DE HAVILLAND AIRCRAFT of CANADA

STANDARDS SHEET

DRAWN	GLADSTONE	CLASSIFICATION	STANDARD
CHECKED	HUTCHINGS	SEAL	CVR 99
STRESSED	FIDDING		
APPROVED	SWANN

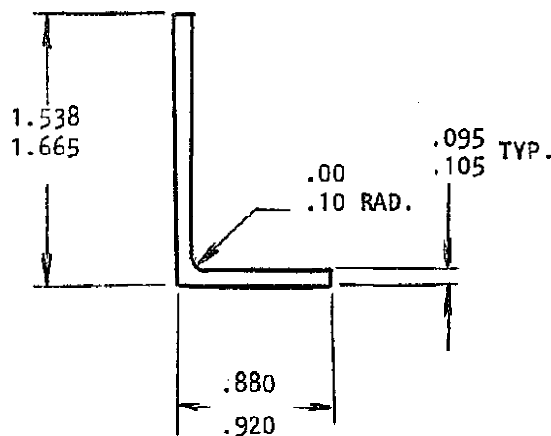
FLAMMABILITY REQUIREMENTS CHANGED

⑦ FAR 25.853(b-2) AMO. 25-51 AND 45° BURN THROUGH
TEST ONLY OF FAR 25.855(A-1) Amend. 25-51
CVR99-2 Material: Physical properties as per AMS3302 Silicone modified
to meet FAR 25.855(A-1) Amend. 25-51, min. length 10'
or increments thereof.
